To: Members of Dublin City Council
From: Marsha I. Grigsby, City Manager *mlg*
Date: June 27, 2013
Initiated By: Steve Langworthy, Director of Land Use and Long Range Planning
Paul Hammersmith, P.E., Director of Engineering/City Engineer
Re: Preliminary Plat of Rights-of Way for John Shields Parkway, Trinity Street, Tradala Row, Tollgate Avenue, and Dublin Center Drive (Case 13-052PP).

This is a request for review and approval of a Preliminary Plat for 7.091 acres of public right-of-way in the Bridge Street District. This plat (which will be followed by a separate Final Plat application) establishes a new street system for a portion of the Dublin Village Center (DVC) site within the Bridge Street Corridor Sawmill Center Neighborhood (BSC-SCN) District. No individual lots are proposed with this Preliminary Plat; however, the new rights-of-way will establish the boundaries of the proposed 324-unit Edwards Communities apartment building currently under review by the Administrative Review Team.

Figure E. Proposed John Shields Parkway Section with shared bicycle/vehicle lanes, pavement markings and traffic signs

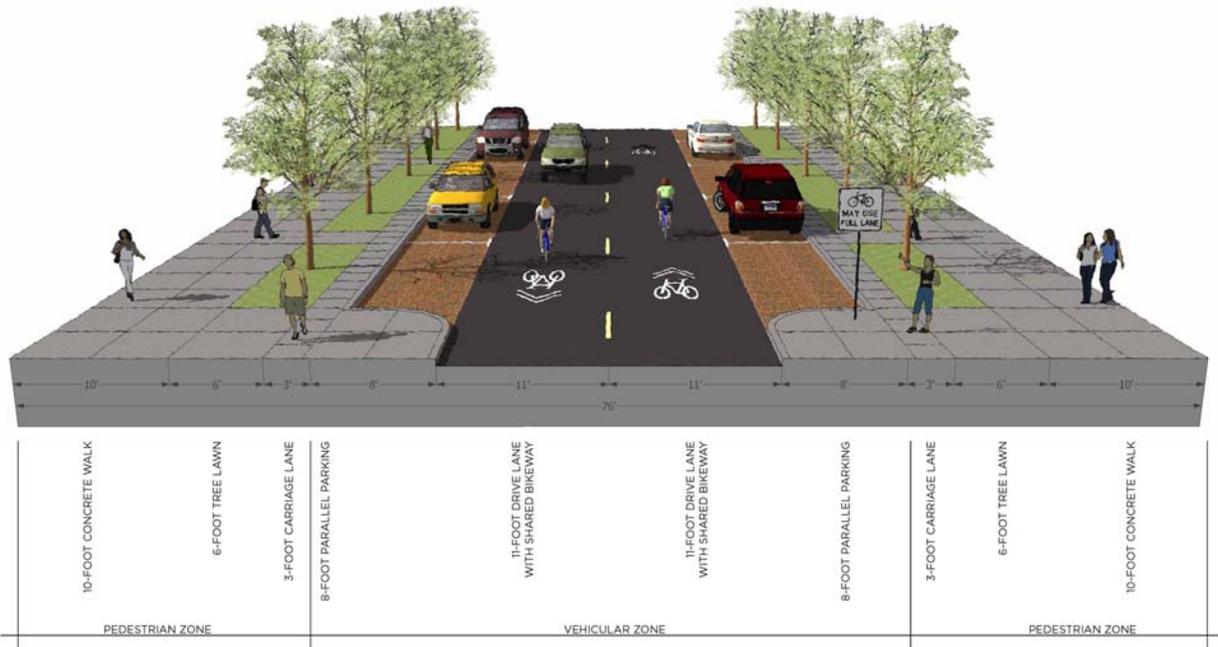
During the Planning and Zoning Commission's review of the Preliminary Plat, the Commission felt that neither of the proposed street sections (either the two-way bicycle/pedestrian path on the north side of John Shields Parkway, or the wide lane/sharrow configuration) adequately met the original Basic Plan condition requiring "a designated bicycle way." The Commission recommended that staff continue to explore an acceptable solution and added the following condition of approval (Condition 5) to the Preliminary Plat:

The Commission also added a condition of approval (Condition 3) to provide minimum 5-foot wide tree lawns and minimum 8-foot wide sidewalks on John Shields Parkway.

Staff has continued to work with the applicant to find an acceptable solution to accommodate bicycle travel on John Shields Parkway while addressing the design objectives reflected in the Commission's condition. Another option that was considered would have further widened the pavement width to provide a striped and dedicated bicycle lane adjacent to the parallel parking lane. However, staff has concerns with this approach for the same reasons noted above for the wide lane/sharrow option.

The applicant has provided a revised Preliminary Plat for Council's consideration. The proposed street section for John Shields Parkway (Figure E) includes 11-foot wide "shared lanes" and 8-foot wide parallel parking lanes. The shared lanes include sharrow markings in the *center* of the travel lane, rather than within the "door swing zone" at the edge of the travel lane, with no increase to the overall lane width. Additionally, the street will be signed to clearly indicate that bicyclists may use the full lane, using appropriate pavement markings and traffic sign standards per the Ohio Manual on Uniform Traffic Control Devices (OMUTCD).

In addition to the pavement markings and signs encouraging cyclists' full use of the shared travel lanes, the preferred street section includes a 6-foot wide tree lawn and a 10-foot wide sidewalk. Both the tree lawn and sidewalk dimensions exceed the minimums requested by the Commission. The wider sidewalk reinforces the Commission's desire for an active pedestrian-oriented street and is consistent with the planning and design objectives for streets within the Sawmill Center Neighborhood District.

While this solution does not meet the letter of the Planning and Zoning Commission's condition to provide a "separately designated" bicycle facility, staff believes that it meets the spirit and intent of designing John Shields Parkway within the Dublin Village Center as a bicycle-friendly street with an inviting pedestrian realm. This design solution will help avoid conflicts with bicyclists and vehicles by setting a clear expectation for both motorists and cyclists that cyclists are expected to ride within the travel lane and motorists are expected to respect their right to do so.
